Project Reference : West Kowloon Reclamation Competition
 Re : Revised Layout
 Date : 10 Sept 2001 Total pages (Incl. this page) : 1 + 3 page(s)

Summary of Feedback from Presentation on Kowloon Waterfront, 3 Sept 2001

WEST KOWLOON WATERFRONT COMPETITION

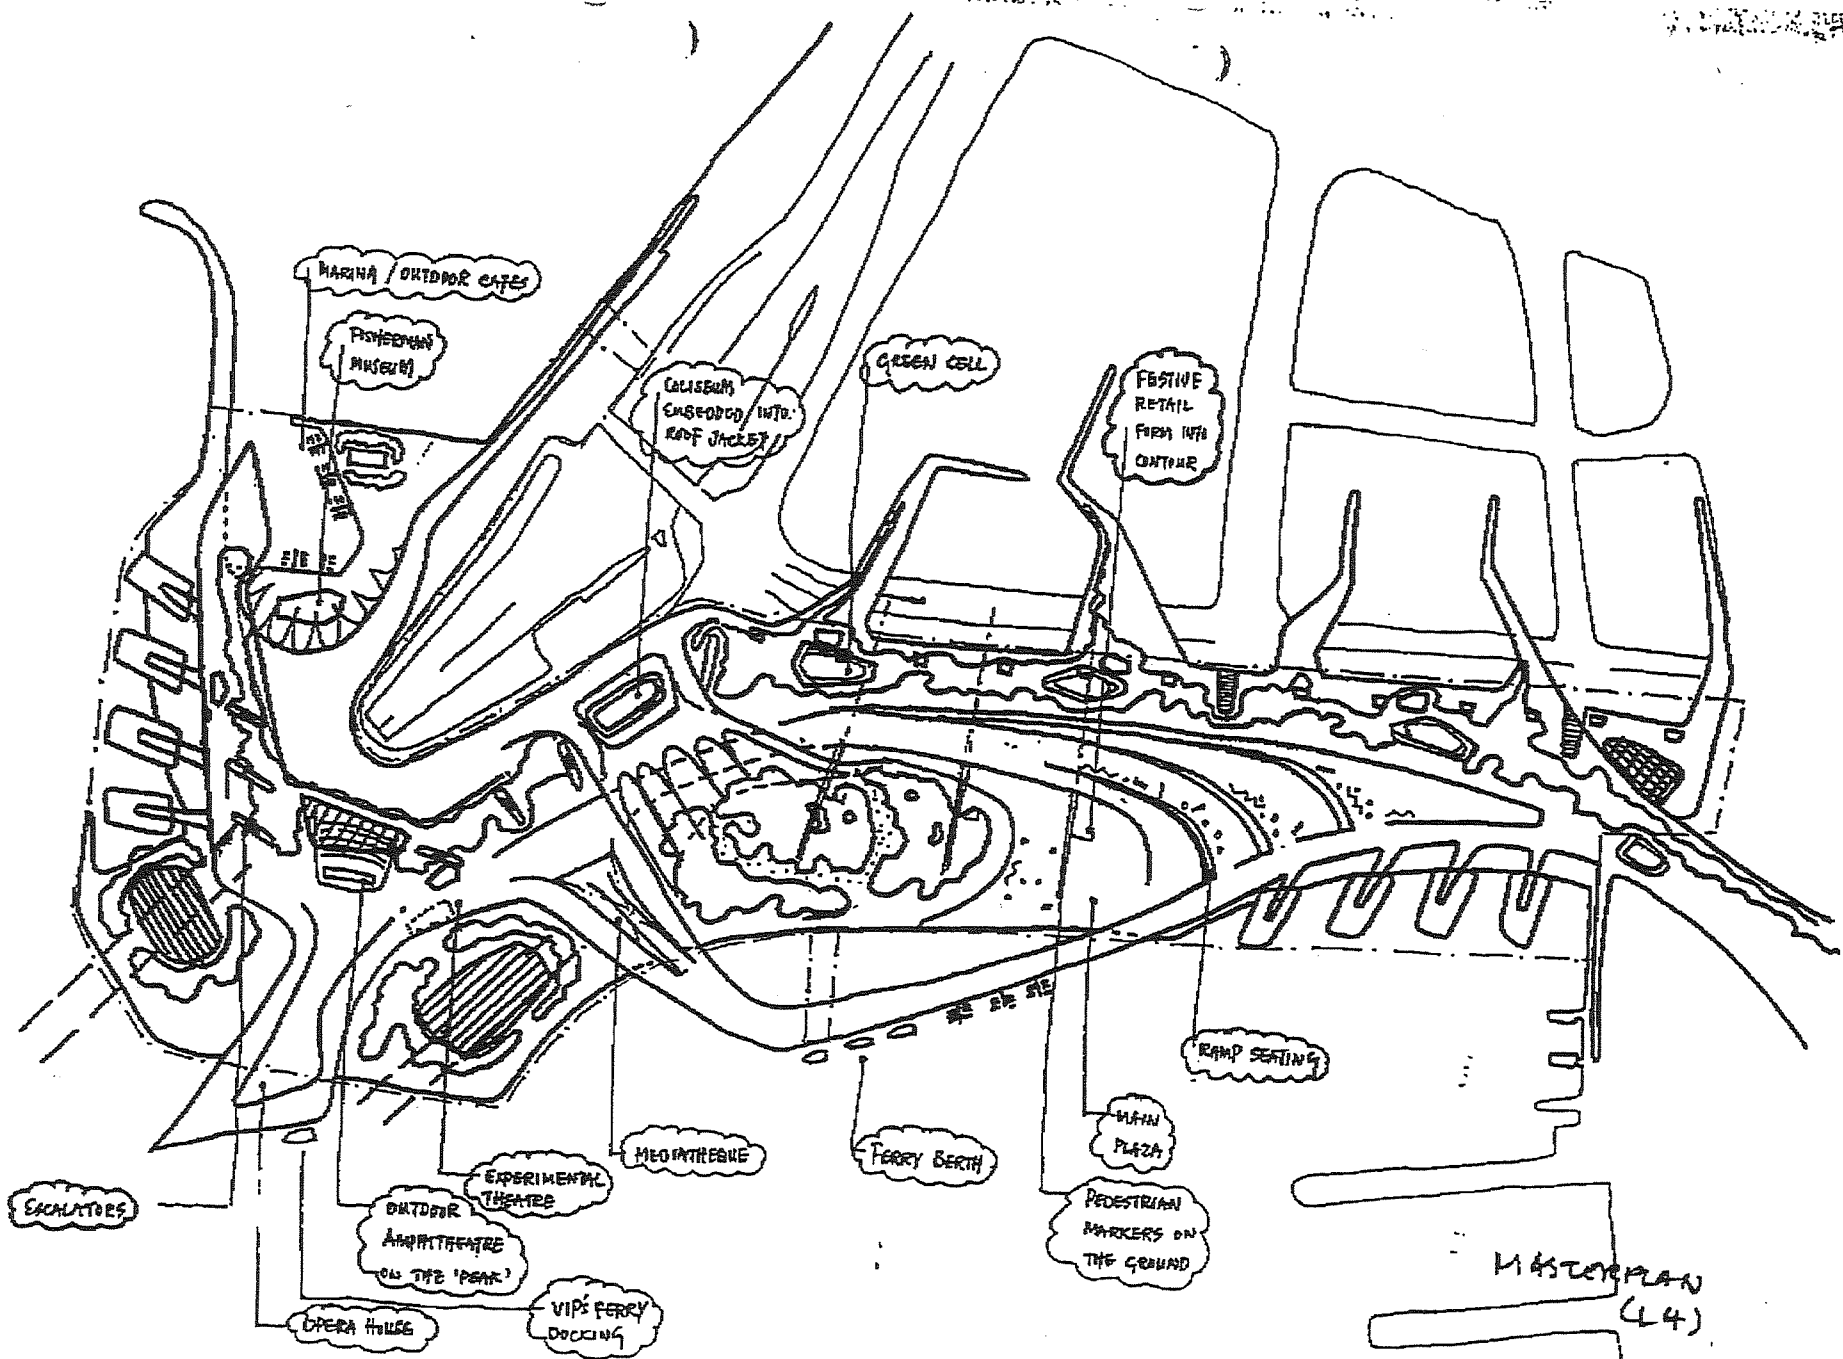
1. Use cultural loop extension 'pretzel' as a jetty and wave break to create a more calm water body within park.

- 2. Lowest platform level shouldn't go beyond -1m from street level.
- 3. Focal element for master plan is not clear.
- 4. Do drawings to show cultural buildings linkages, to illustrate concept of 'necklace with jewels'.
- 5. Thinks that the other 2 teams sponsored by SHK are a little more advanced in their stage of work completed. However they are being paid a lot more?
- 6. Plans rather complicated. To bear in mind that the assessors will need to understand the scheme within a short time. Perhaps to show plans in a more diagrammatic form.
- 7. Incorporate Chinese Elements
examples of Chinese features:
 - Rock garden - pagoda
 - Chinese wall
 - Pergola
 - Arches
 - Broad width can be Chinese -> stone
- 8. Suggested re-orientating the western residential pier towers to extend into the typhoon shelter area and have the marina within the shelter area.
